3/31/09	Added General Note (F)
DATE	REVISION	
STATE OF HAWAII DEPARTMENT OF TRANSPORTATION HIGHWAYS DIVISION BRIDGE GENERAL NOTES INTERSTATE ROUTE H-1 EXTENSION AND REPAIR OF SCHOOL STREET ON-RAMP RETAINING WALL Project No. H11-01-08 Scale: As Noted Date: Feb., 2009

3/31/09	Revised and/or Added Callouts and Legend
DATE	REVISION
STATE OF HAWAII DEPARTMENT OF TRANSPORTATION HIGHWAYS DIVISION RETAINING WALL REPAIR and EXTENSION EXISTING SITE PLAN INTERSTATE ROUTE H-1 EXTENSION and REPAIR of SCHOOL STREET ON-RAMP RETAINING WALL Project No. H11-01-08	
Scale: As Noted	Date: Feb, 2009
SHEET No. Q3 OF 34 SHEETS

RETAINING WALL REPAIR and EXTENSION

RETAINING WALL REPAIR and EXTENSION
PARTIAL LOCATION PLAN
H1 @ Sta. 117+00± to Sta. 113+40±
INTERSTATE ROUTE H-1
EXTENSION AND REPAIR OF
SCHOOL STREET ON-RAMP RETAINING WALL
Project No. H11-01-08

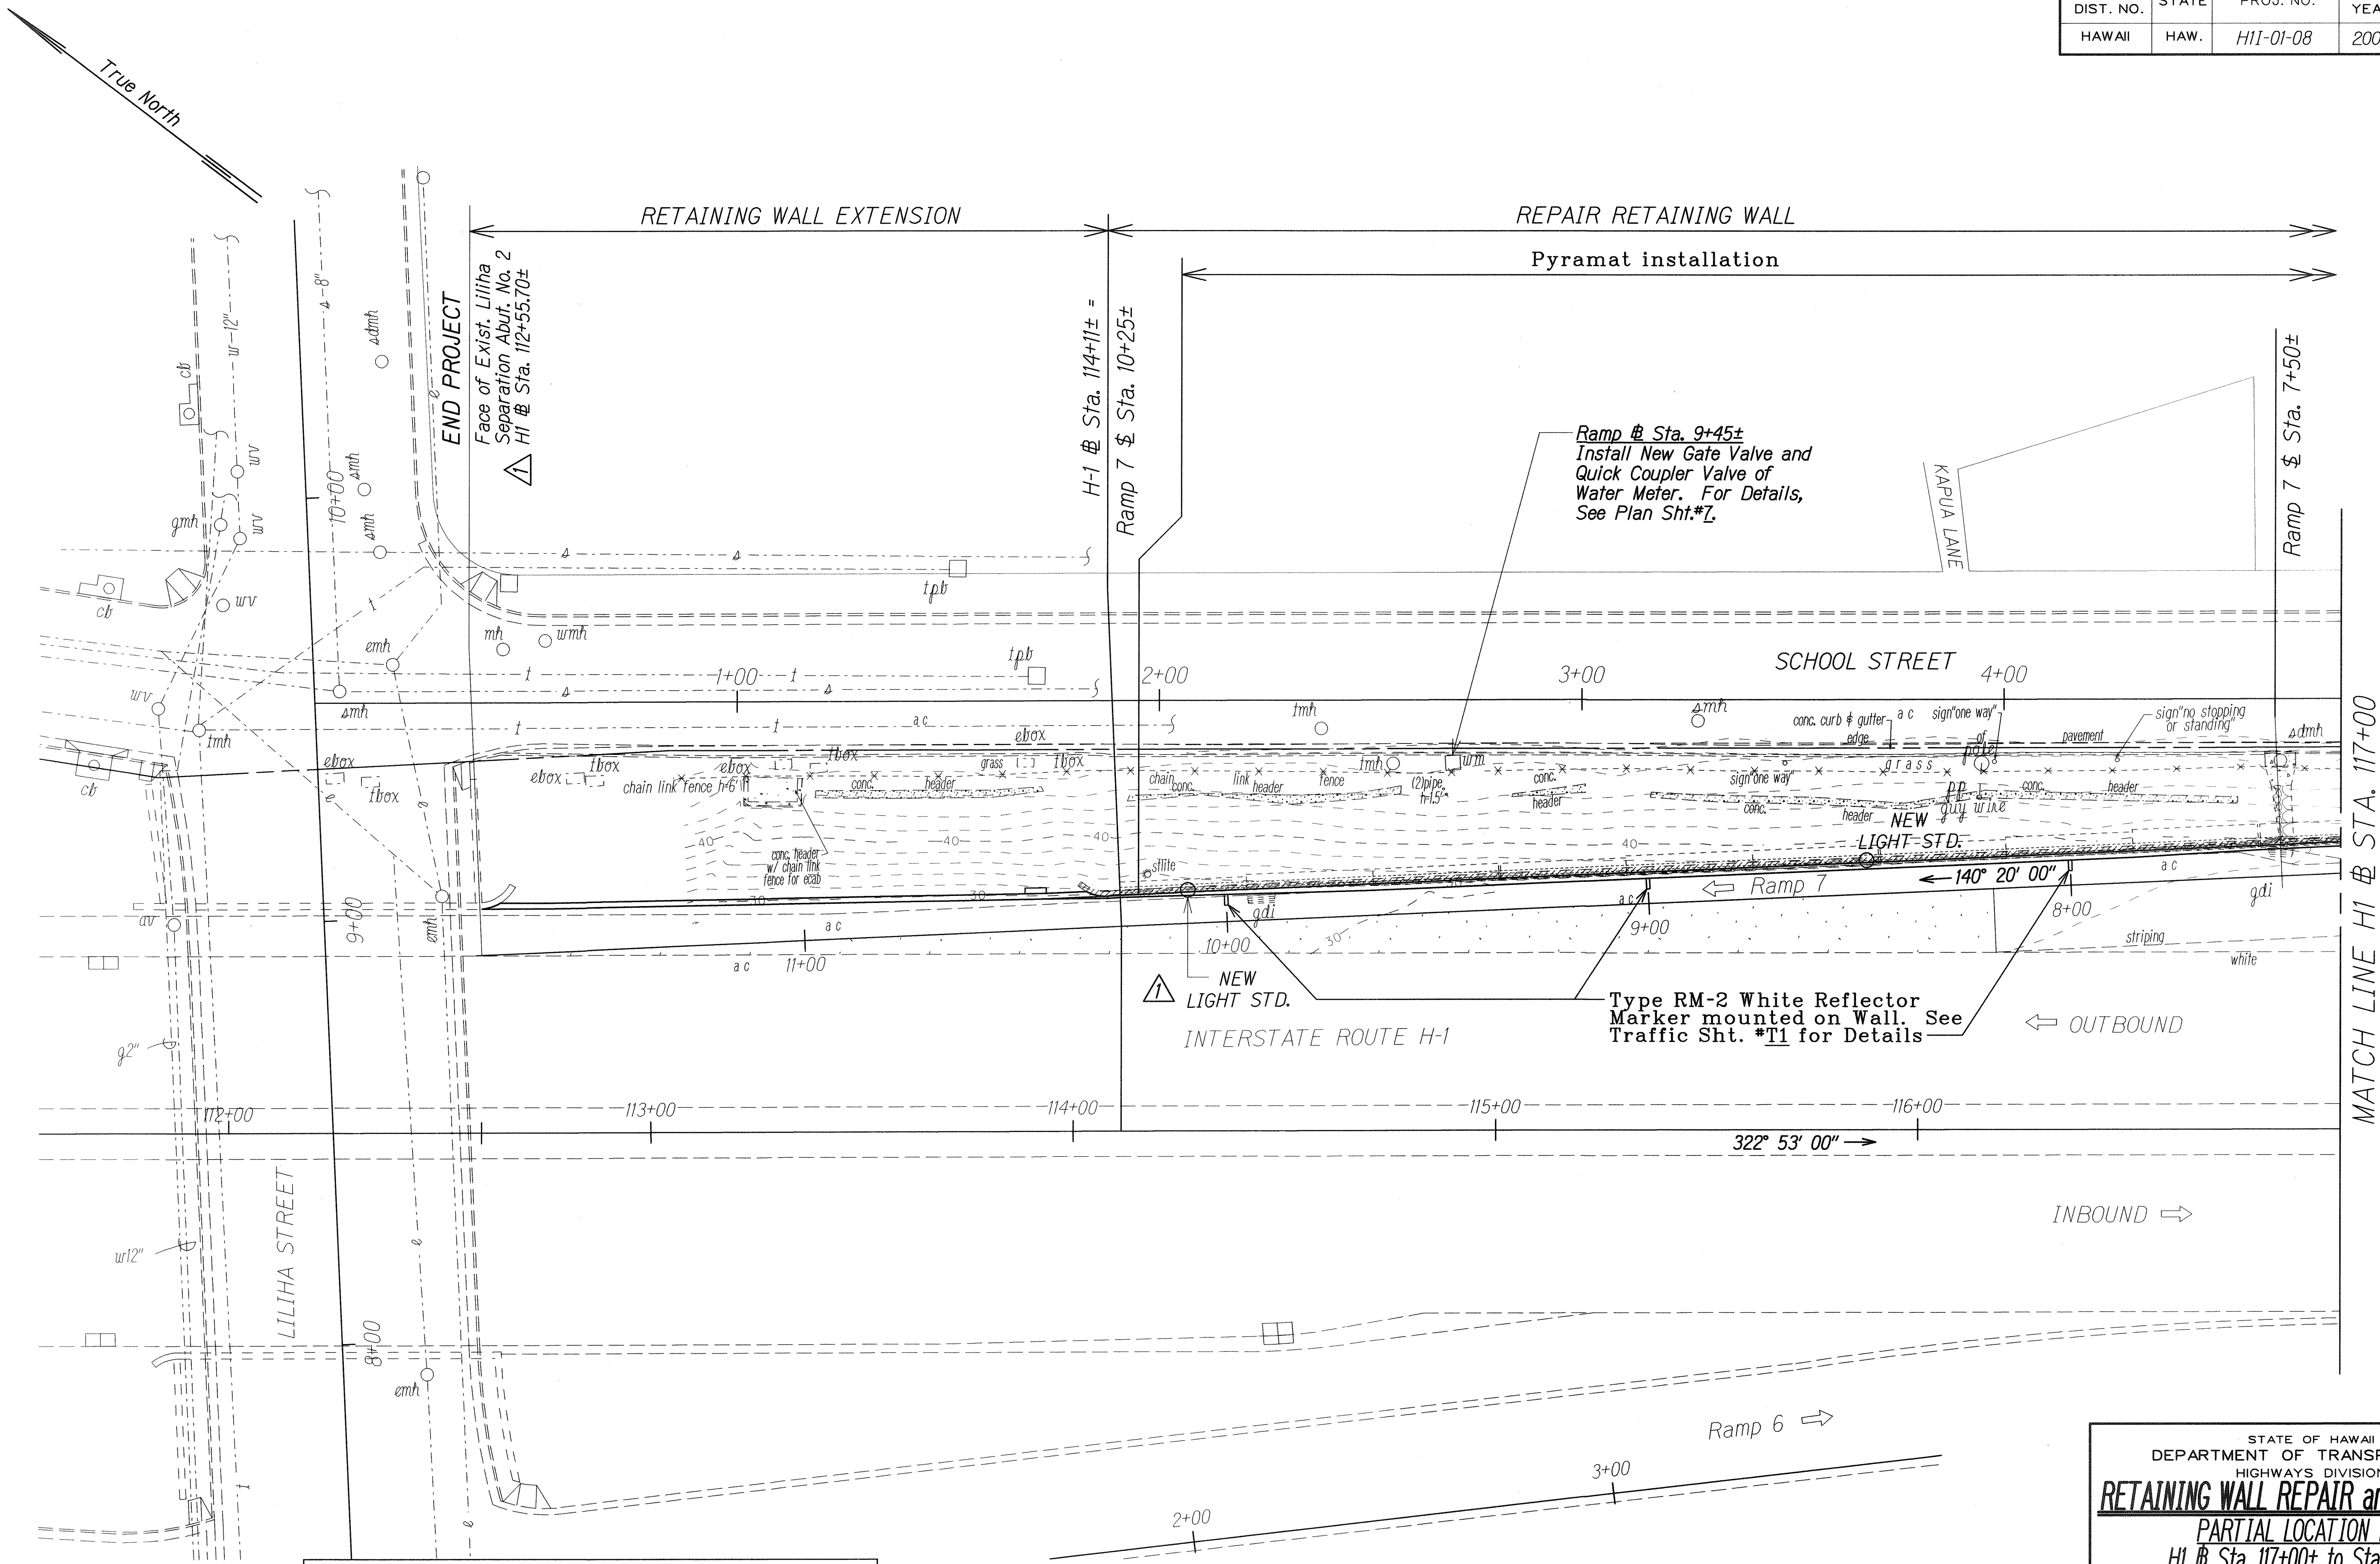
Revised End Project Station Number, Added New Light Standard and Callout
3/31/09	
DATE	REVISION

STATE OF HAWAII
DEPARTMENT OF TRANSPORTATION
HIGHWAYS DIVISION
RETAINING WALL REPAIR and EXTENSION
PARTIAL PLAN, ELEVATION and DETAILS
INTERSTATE ROUTE H-1 EXTENSION and REPAIR
of SCHOOL STREET ON-RAMP RETAINING WALL
Project No. H11-01-08

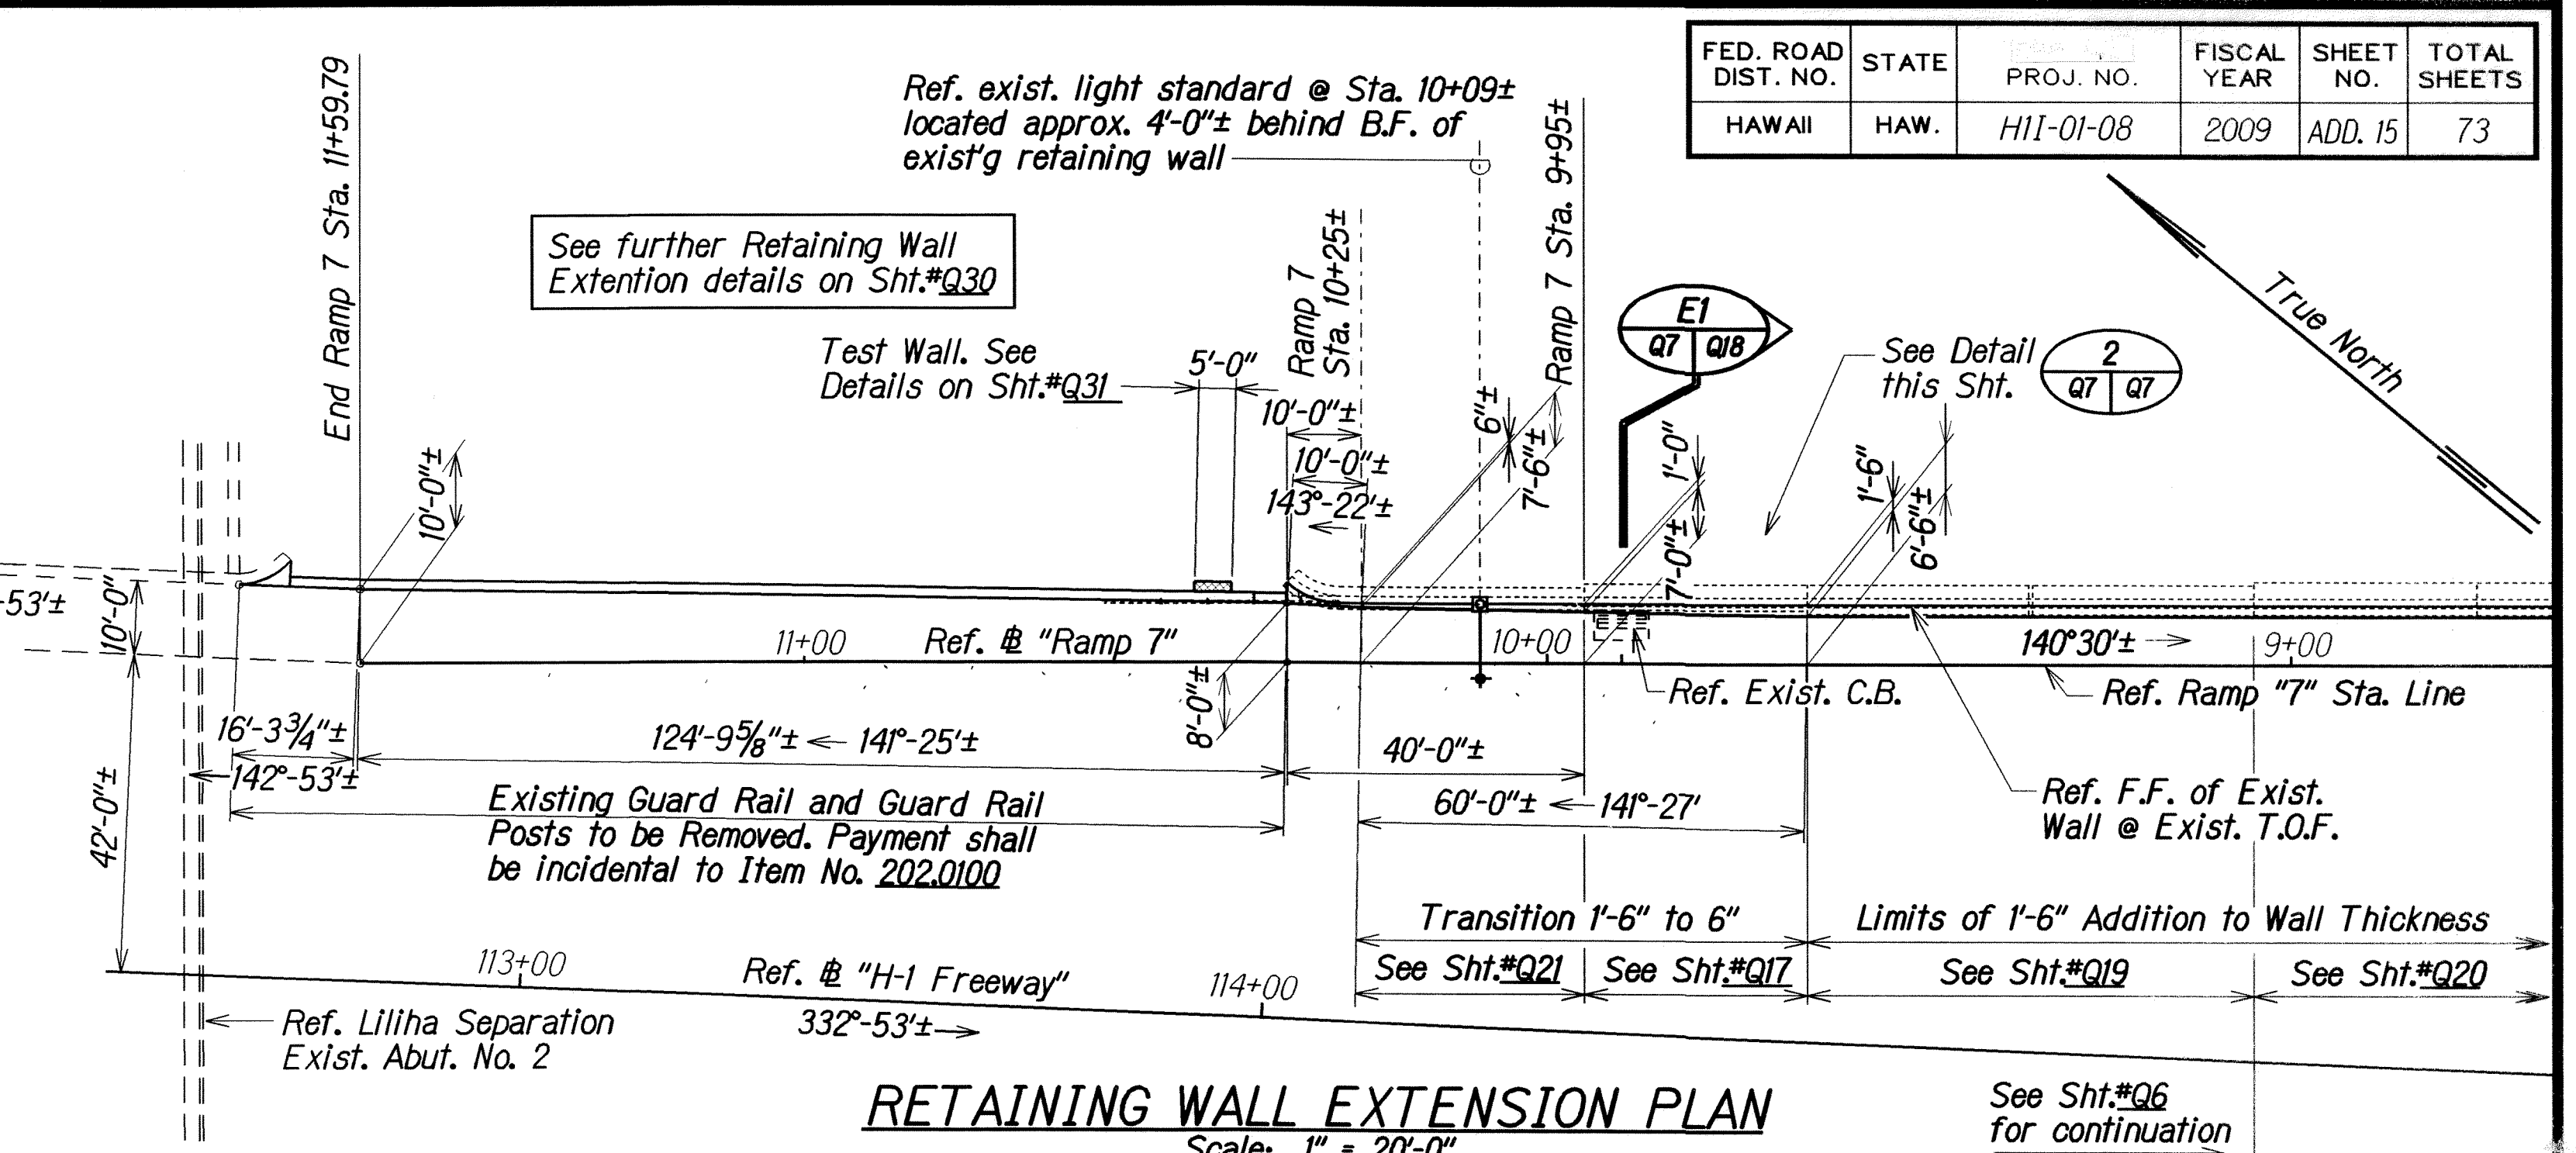
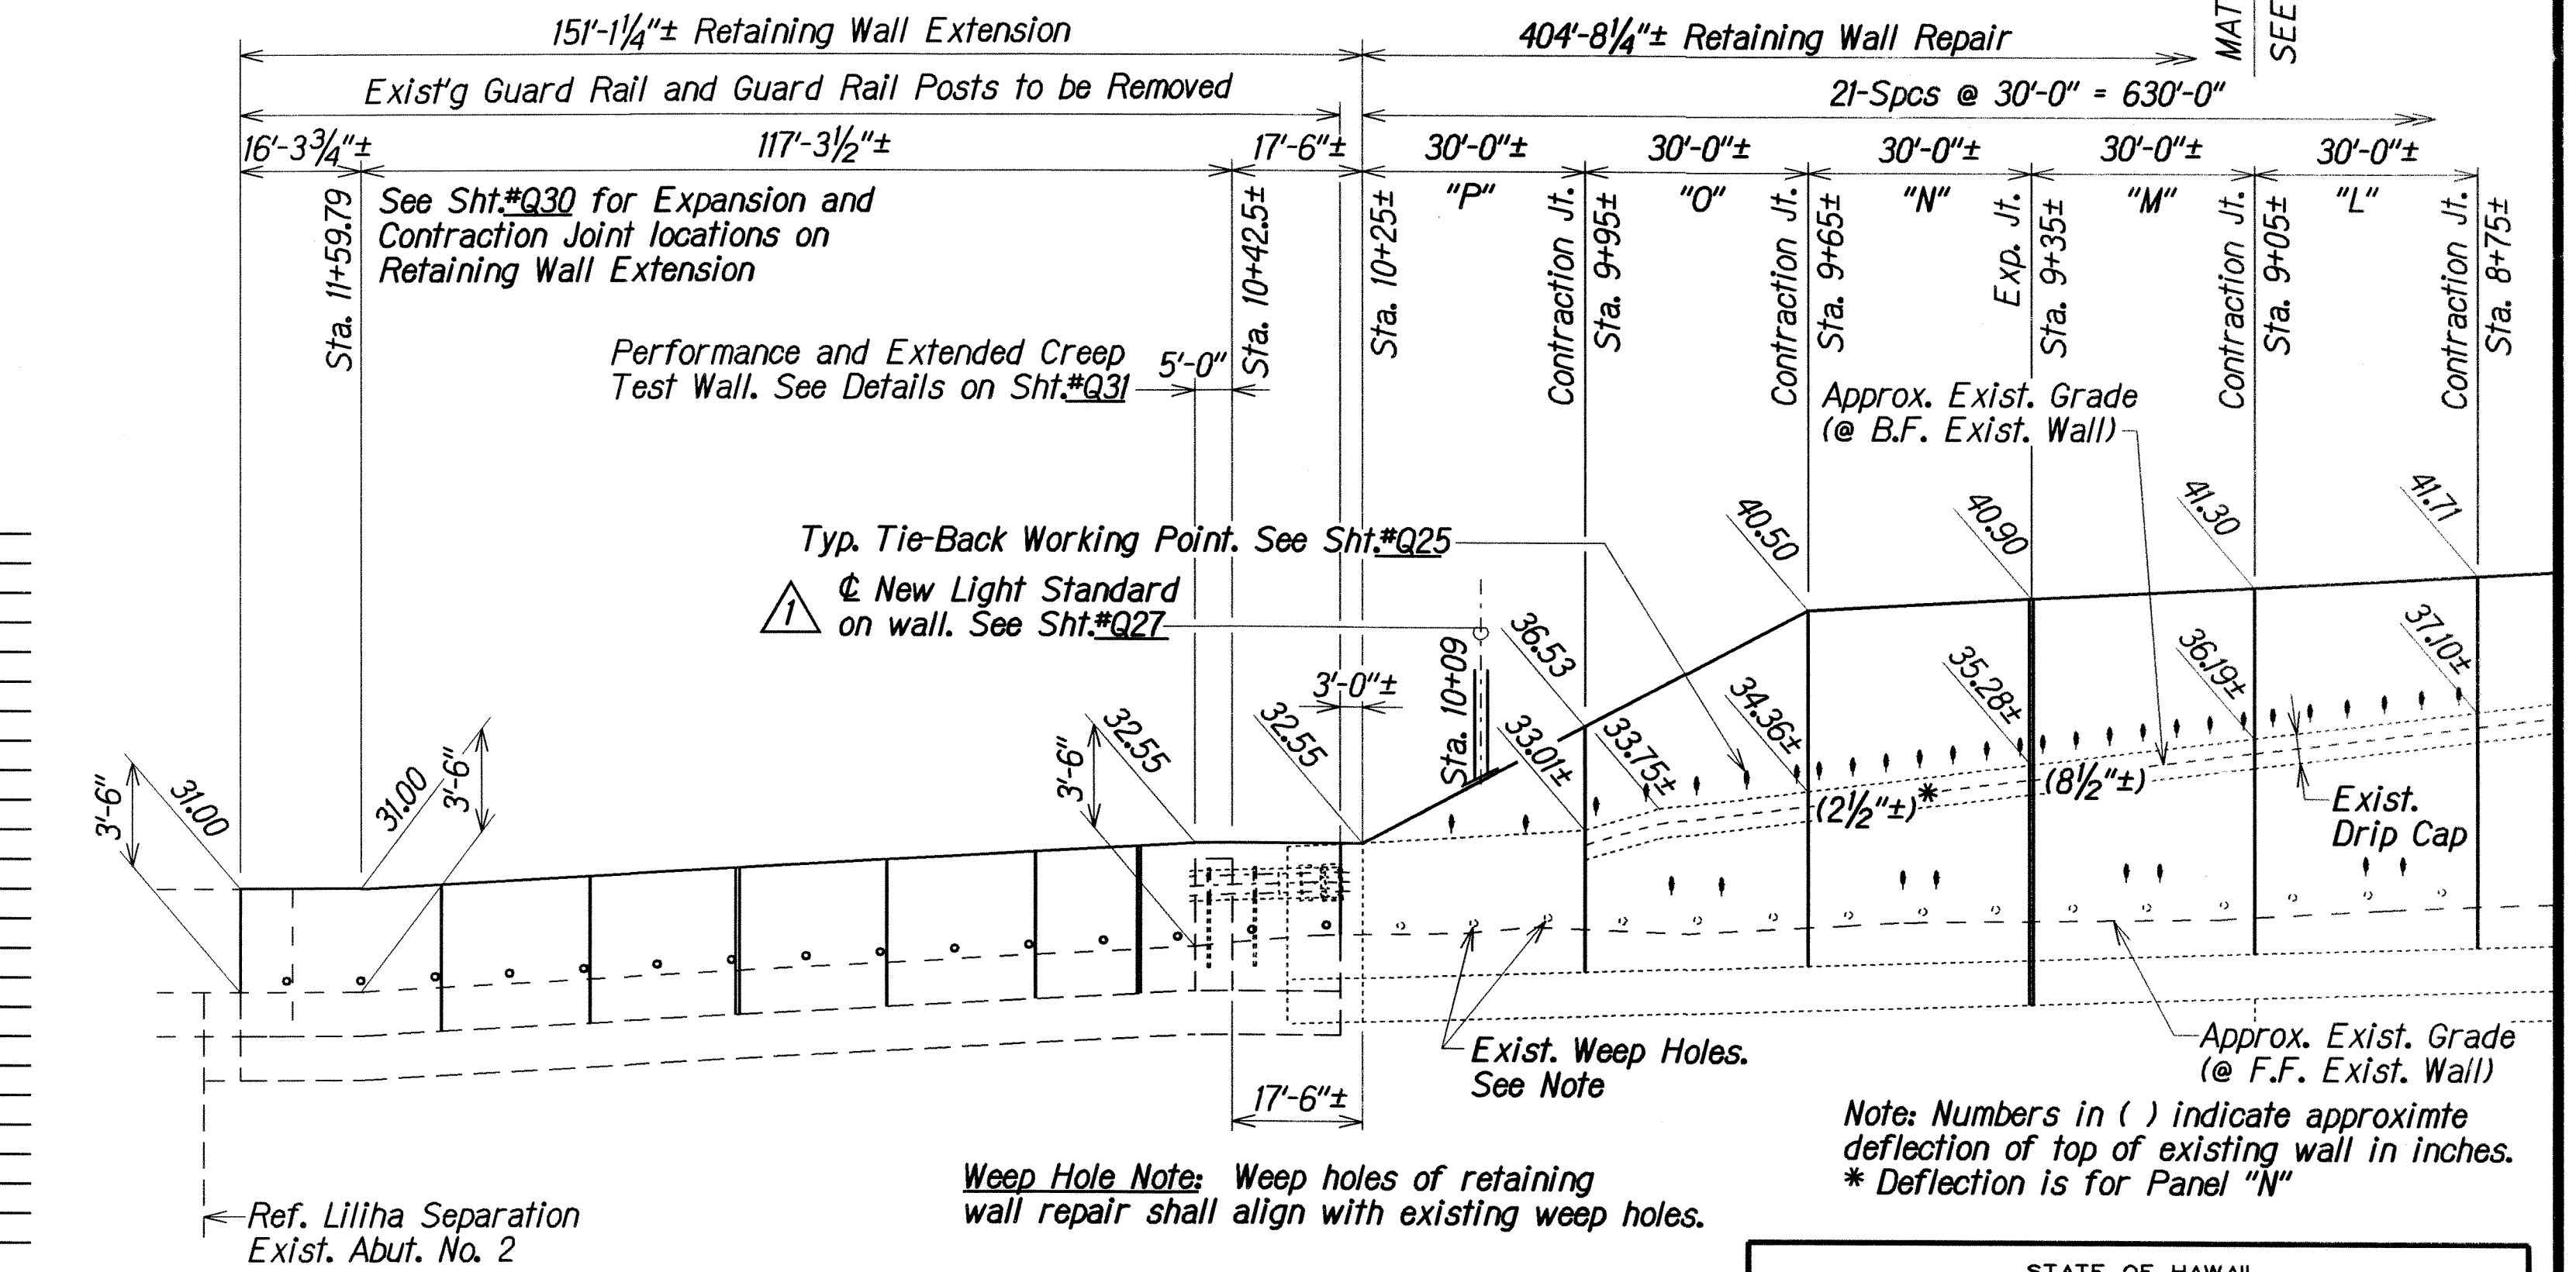
Added Legend for Permanent Tie-Back Anchor & Exist. Weep Hole and Revised New Light Standard Callout
